ISO/TC 197
Hydrogen technologies

ISO DIS 17268 (Ed 3) Collated Comments

Background: These are the collated comments from the DIS 17268 ballot 2017-09.

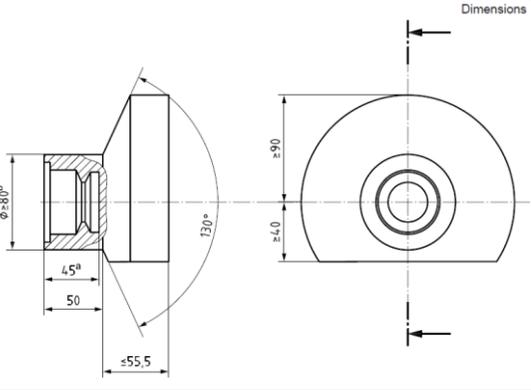
JP 034 01		07.21	all	te	Subclause 7.21 is specifying the test procedure for withstanding exposure to pre-cool hydrogen during fuelling, which is redundant. Verifying leakage at low temperature is performed in Subclause 7.11. The test for the failure to disconnect is also specified in Subclause 7.26, Further, the testing conditions for freezing tests are more reflecting a real environment than 7.21. Then, 7.21 is a kind of duplicate, and not be needed to be left.	Delete the whole Subclause 7.21.	
US 21 035		07.21	Para 2	TE	Three minutes is a goal for completing but five minutes is a more realistic fueling time.	The connector shall be subjected to pre-cooled hydrogen gas at -40 °C at a flow rate of 30 g/s at 15 °C and 90 % relative humidity for a minimum of <u>3 5</u>

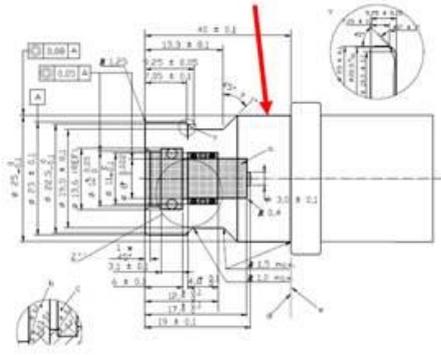
US 24 040		07.26	Bullet c	TE	Three minutes is a goal for completing but five minutes is a more realistic fueling time The gas flow rate should match the maximum in SAE j2601	...passing hydrogen through the interface for 3 <u>5</u> minutes at the following conditions.... Gas Flow Rate: 60±10% g/s <u>650 ± 50 g/min</u>	
US 25 041		9 h)			Dispenser pressure protection is out of the scope of this document.	Delete.	
US 26 042		9 i)			Should refer to component pressure rating or "PS" mark.	<i>Replace with the following:</i> Include the appropriate component pressure rating (or PS mark) per Table 1.  TC 197 U.S. Proposed new Table	
FR 05 043		Annex A	figure A.1	Te	Drawing unclear	Come back to previous definition :
